## 10.4 Other Features of Steam and Power Conversion

The information in this section of the reference ABWR DCD, including all subsections, tables, and figures is incorporated by reference with the following departures and supplements.

Figure 10.4-5 Condensate System

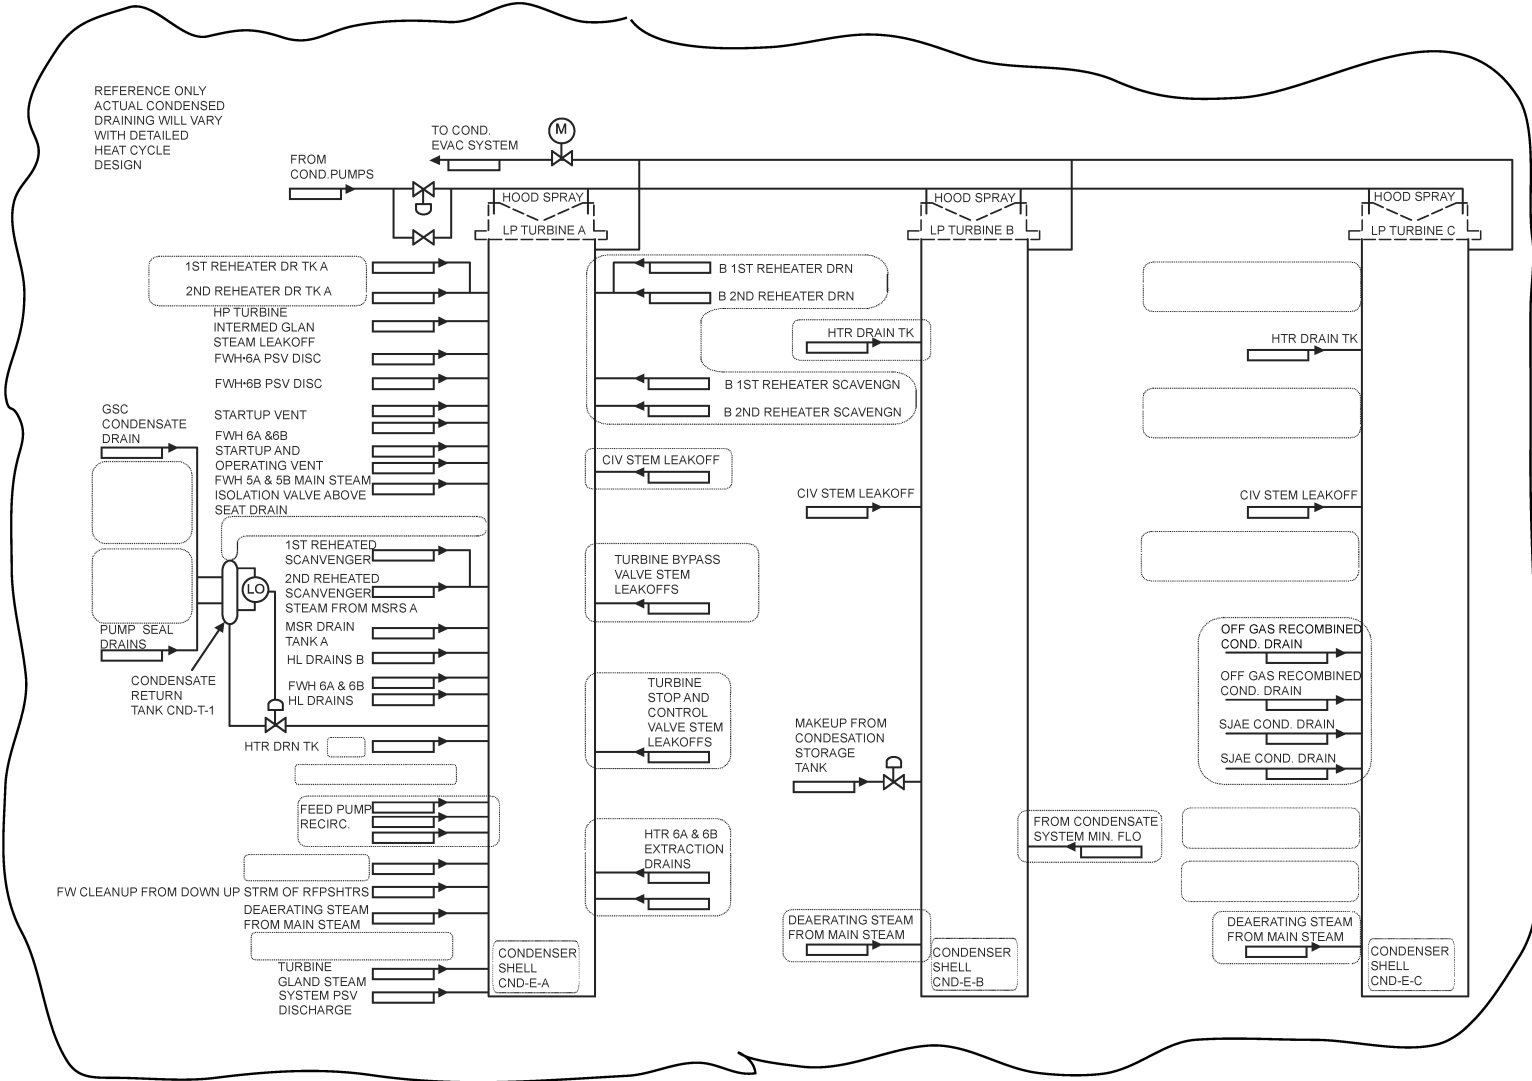
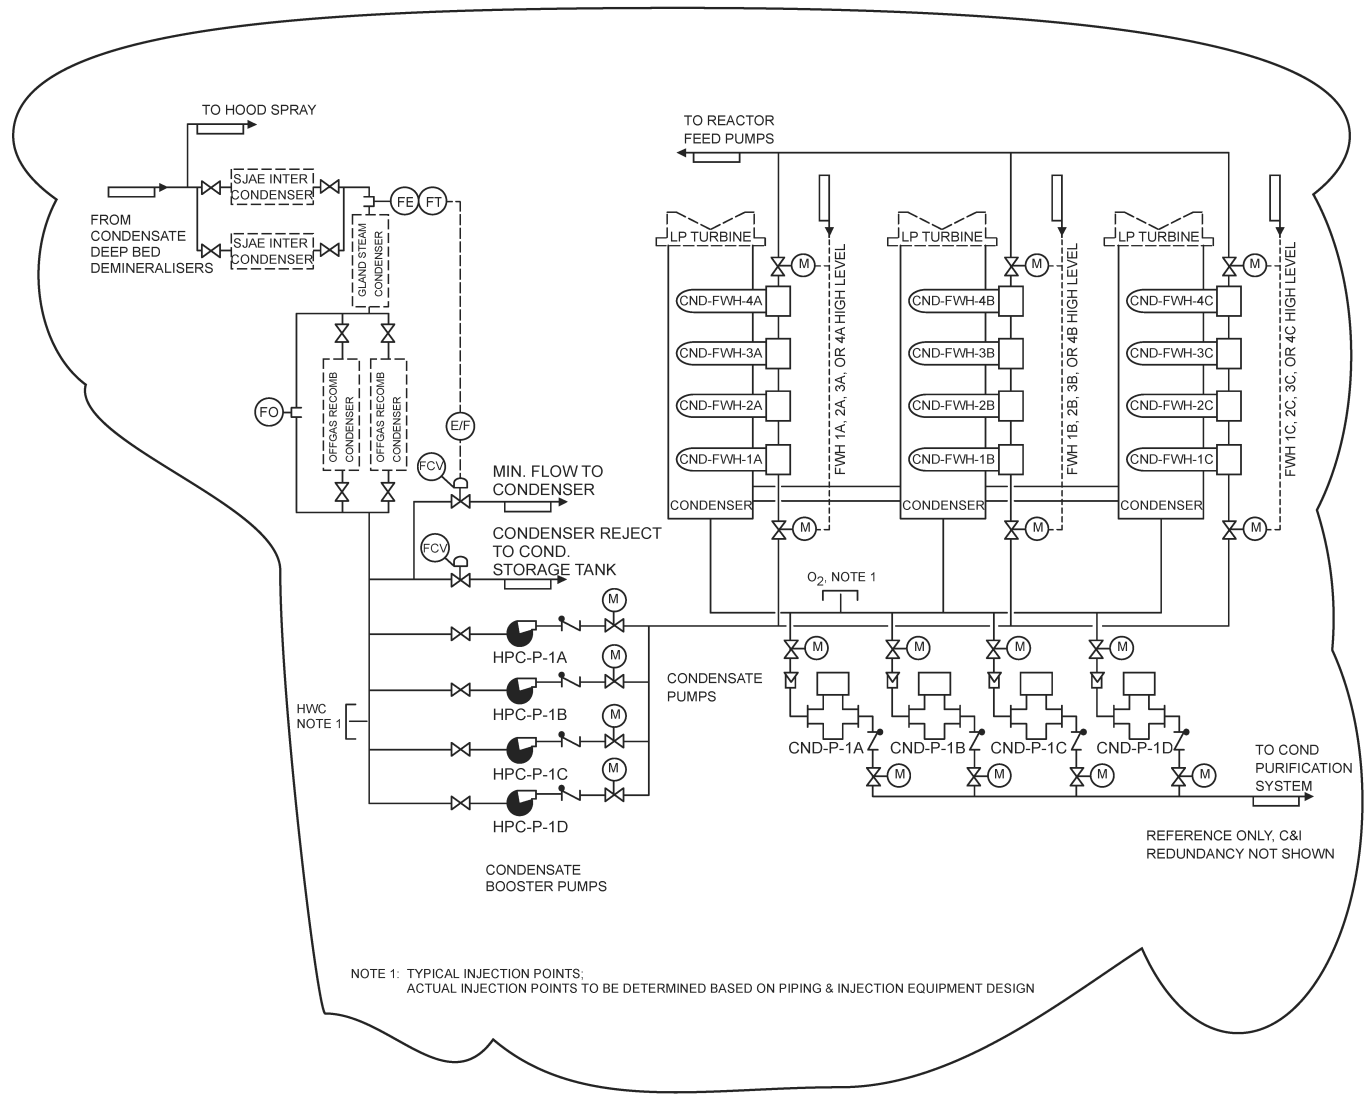
STP DEP 10.4-5 (Table 10.4-5, Table 10.4-6, Figures 10.4-5, 10.4-6, 10.4-7, 10.4-8)

The CFS consists of four ~~33-50%~~ 33% capacity condensate pumps (three normally operating and one on automatic standby), four 33% capacity condensate booster pumps, (three normally operating and one on automatic standby), ~~three normally operated 33-65%~~ four 33% capacity reactor feedwater pumps (three normally operating, one on automatic standby), four stages of low-pressure feedwater heaters, and two stages of high- pressure feedwater heaters, piping, valves, and instrumentation. The condensate pumps take suction from the condenser hotwell and discharge the deaerated condensate into one common header which feeds the condensate filter/demineralizers.

Figure 10.4-6 Feedwater System

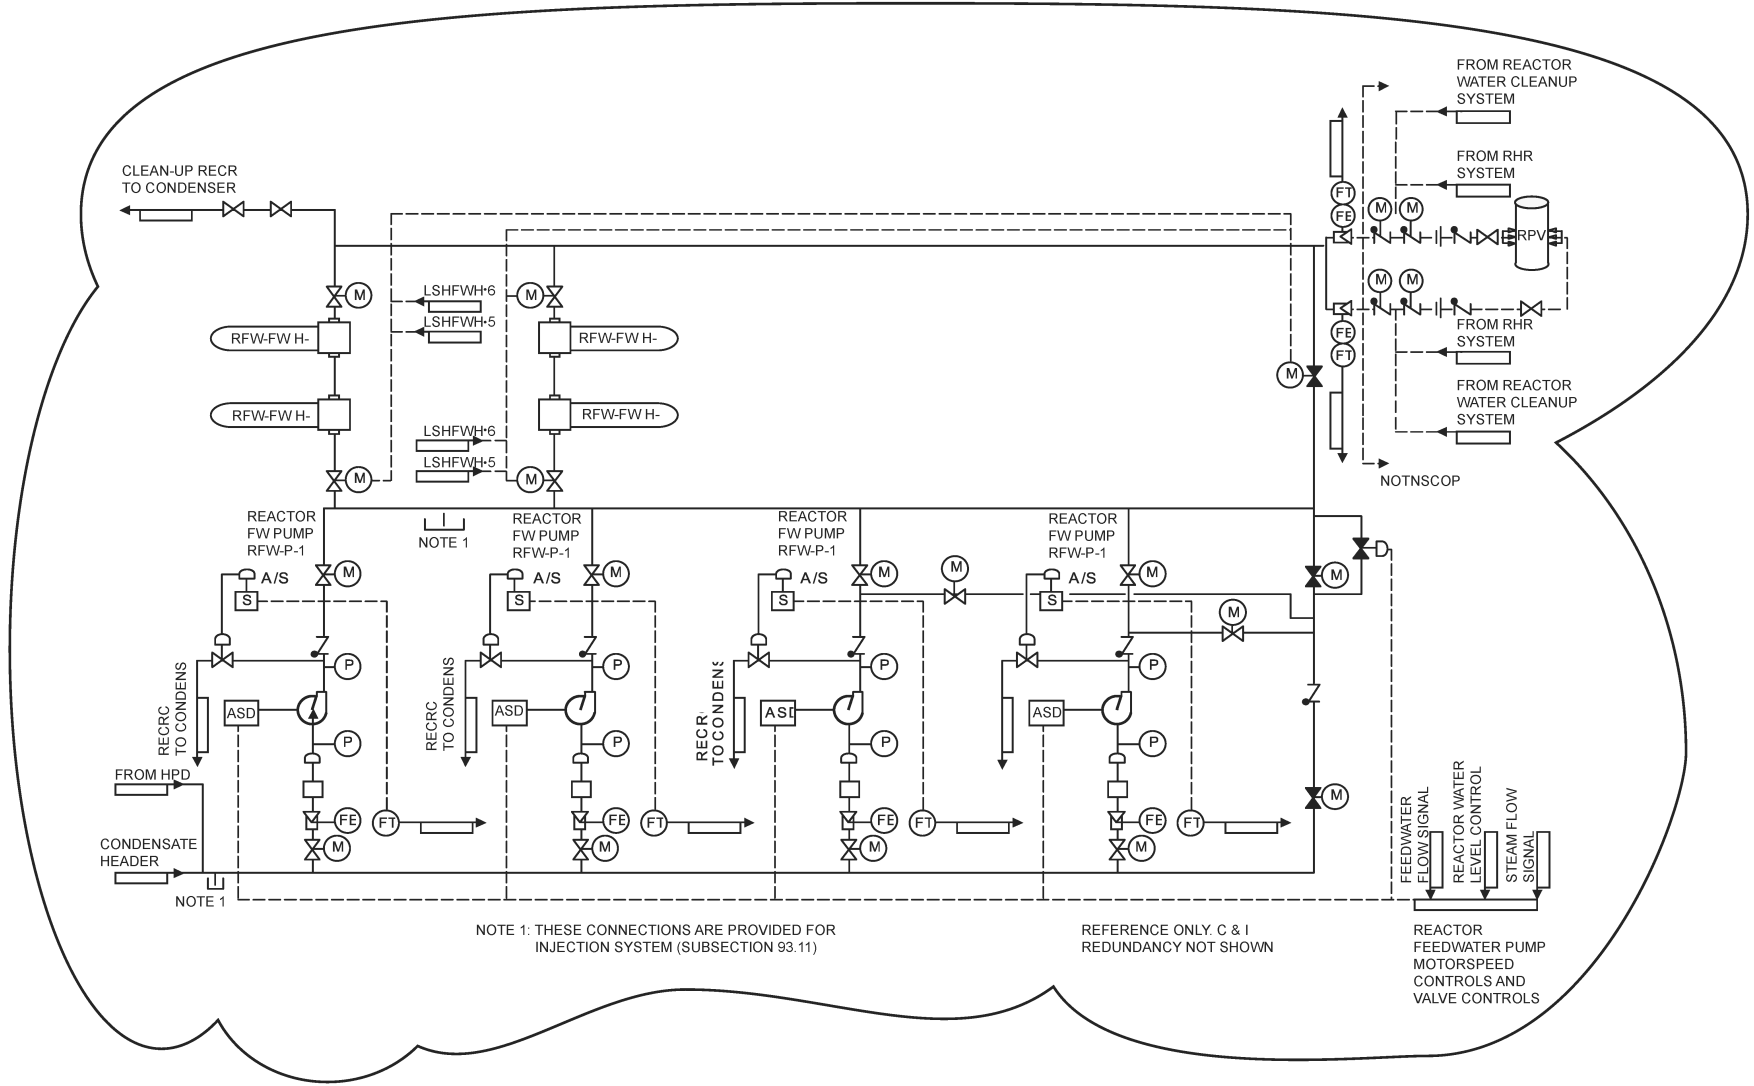
Another bypass, ~~equipped with a feedwater flow control valve~~, is provided around the high-pressure heaters to ~~perform two independent functions~~. ~~During startup, the bypass and its flow control valve are used to regulate the flow of feedwater supplied by either the condensate pumps or the reactor feed pumps operating at their minimum fixed speed~~. ~~During power operation, the heater bypass function is to maintain full feedwater flow capability when a high-pressure heater string must be isolated for maintenance~~.

To minimize corrosion product input to the reactor during startup, recirculation lines to the condenser are provided from the ~~reactor feedwater pump~~ condensate booster

Figure 10.4-9 Bypass Valve Control, Electro-Hydraulic Control Unit

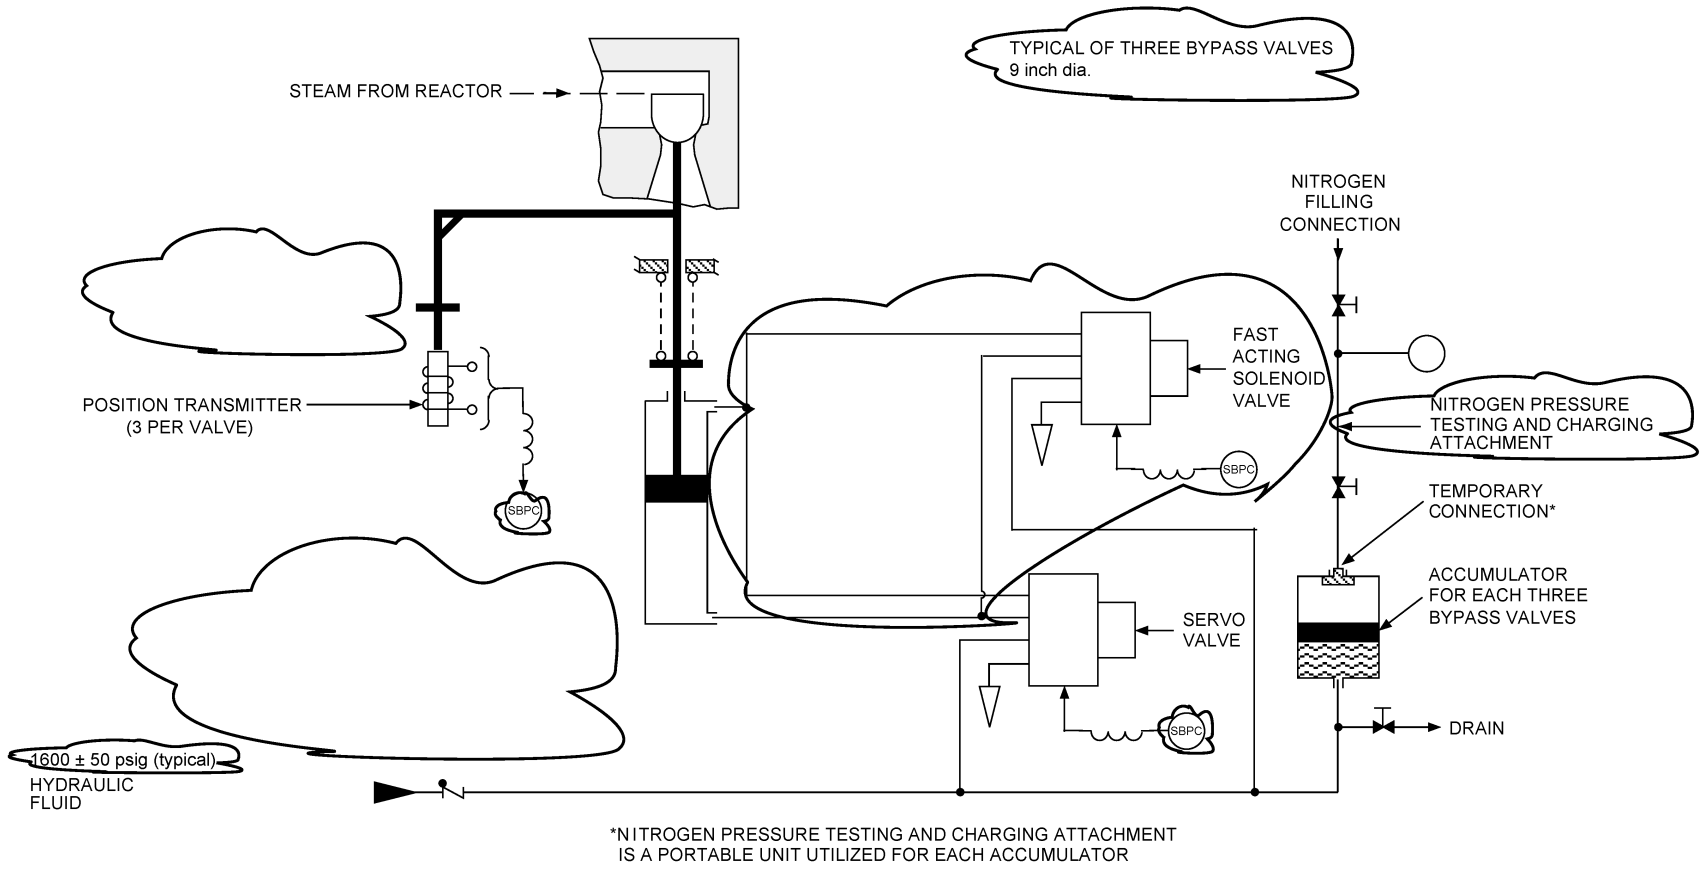
STD DEP 10.4-7 (Figure 10.4-9)
